MONTGOMERY COUNTY DEPARTMENT OF PARKS
THE MARYLAND-NATIONAL CAPITAL PARK AND PLANNING COMMISSION

MEMORANDUM

SUBJECT: Amendment to the Facility Plan for the North Branch Hiker Biker Trail

Approve modifications to the 2013 Facility Plan for the North Branch Hiker-Biker Trail, specifically:

Recommended trailhead/parking lot location.

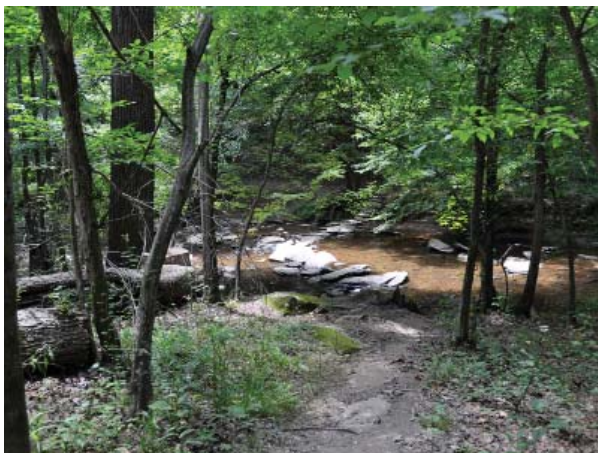
In light of substantial community support for Option B, Parks staff is recommending that the Planning Board approve the relocation of the proposed North Branch Trail trailhead and parking lot from Muncaster Mill Road to Meadowside Lane. Although Option B comes with several advantages over Option A, there are still some potential drawbacks worth consideration. Advantages:

- Steeper trail grades from parking lot to main trail (compared to Muncaster Mill).
- Impacts to forest edge, including tree removals.
- Detriment to visual character of Meadowside Lane.
- Additional scope and fee for design consultant.
- Project schedule delay for additional survey and redesign of the trailhead and parking lot.

Proposed bridge locations along the North Branch Trail.

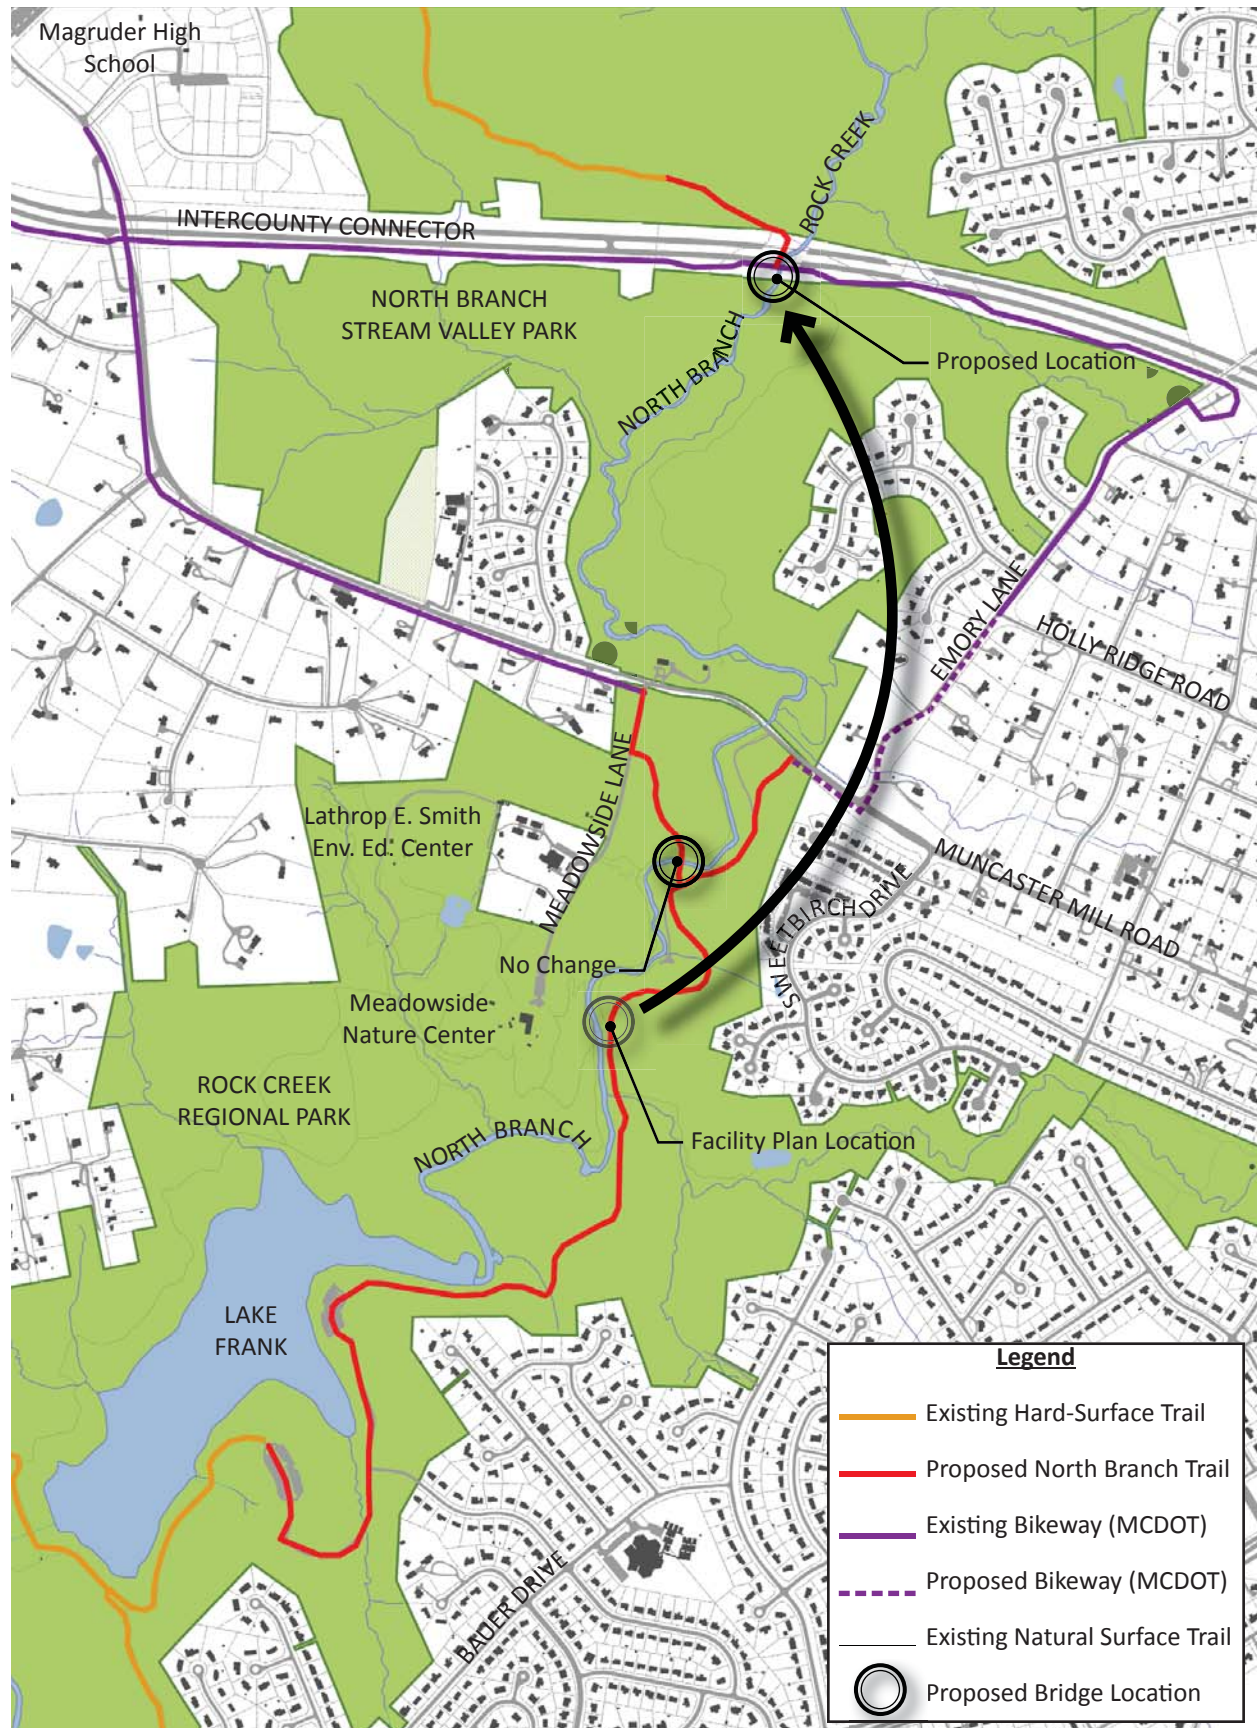
In a matter separate from the proposed parking lot and trailhead relocation, staff is seeking approval to move a six-foot wide bridge from the location proposed in the Facility Plan to a location better suited to meet current trail use patterns and to accommodate future trail planning efforts. The Facility Plan for the North Branch Trail calls for two bridge crossings of the North Branch between Lake Frank and Muncaster Mill Road. The first bridge crossing occurs roughly halfway between Muncaster Mill Road and the Meadowside Nature Center and provides a connection from the main trail directly to Meadowside Lane. This bridge is proposed to be a 12-foot wide crossing to accommodate hikers, bikers and small maintenance and emergency vehicles. No change is proposed for this crossing.

The second bridge crossing occurs approximately 1,000 feet south of the larger crossing, and links the North Branch Trail to the steep natural surface trails that lead to the Meadowside Nature Center. Staff is proposing to relocate this small bridge to a point along the North Branch Trail just south of where the ICC crosses over the North Branch. Currently, each location allows users to ford the stream via a rudimentary stone crossing. Staff proposes to maintain the existing stone crossing near the Meadowside Nature Center and replace the crossing just south of the ICC with a bridge.

Existing crossing at the ICC. This crossing would be replaced by a bridge.

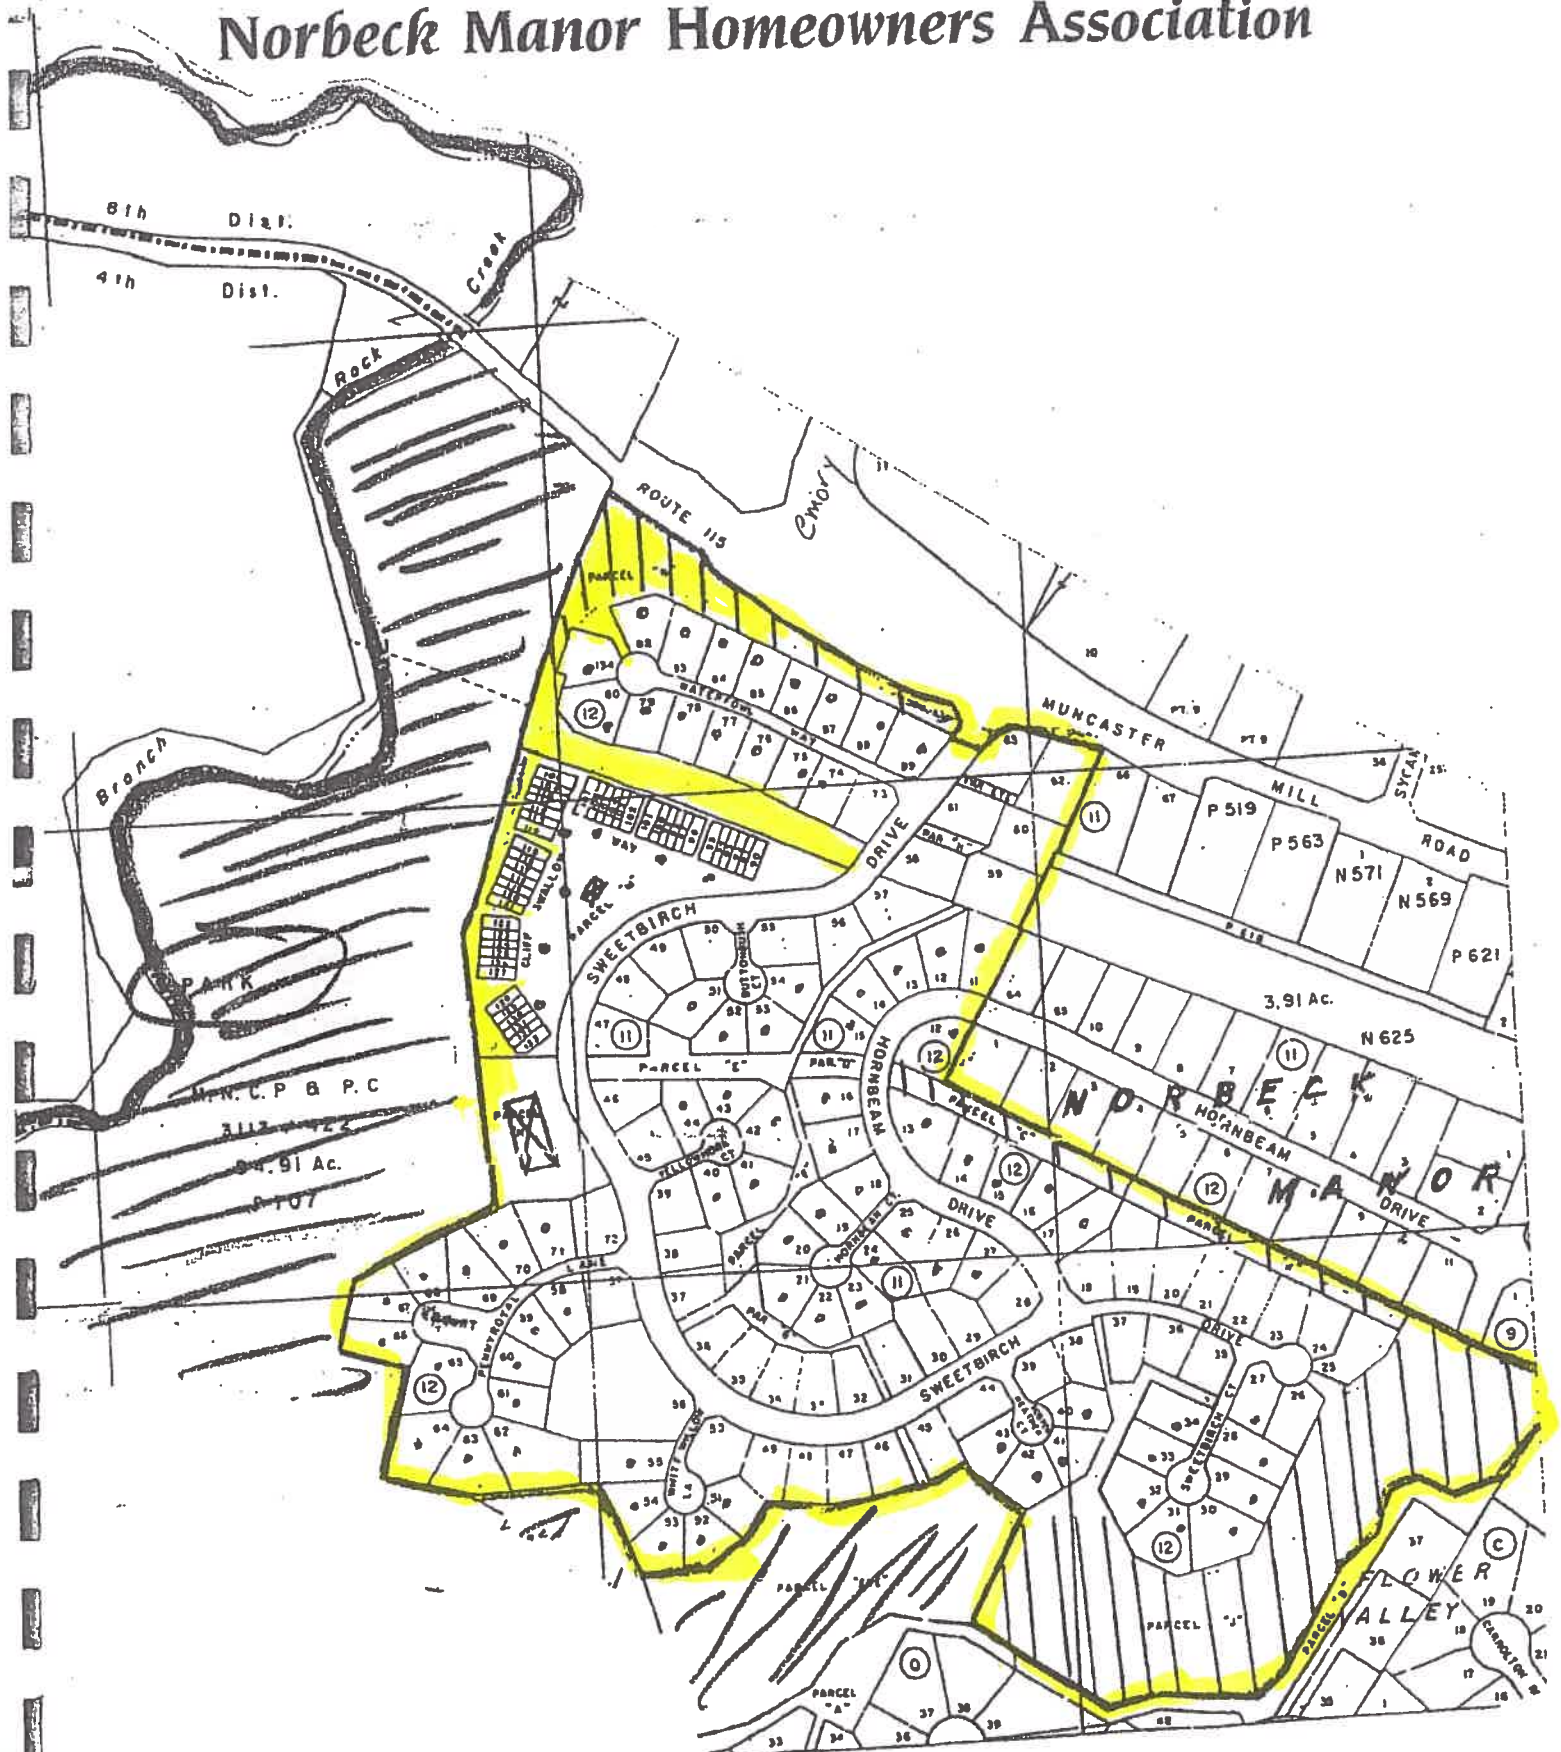
III.C. A trail can be designed and routed from the south side of the bridge and creek below the barn on the Kengla property to the southern boundary corner of MNCPPC property adjoining Muncaster Mill Road and the privately owned parcel on the corner of Muncaster Mill and Emory, where it will then run within the SHA right of way from where the privately owned parcel begins to the corner of Emory Lane and Muncaster Mill Road.

As noted, the south side of the North Branch Creek on this side of Muncaster Mill Road is not within the Special Protection Area and, from the area of the barn, it does not appear to have a dense stand of trees or much underbrush, unlike the route of the proposed paved path up the hill from the bridge to the proposed parking lot.
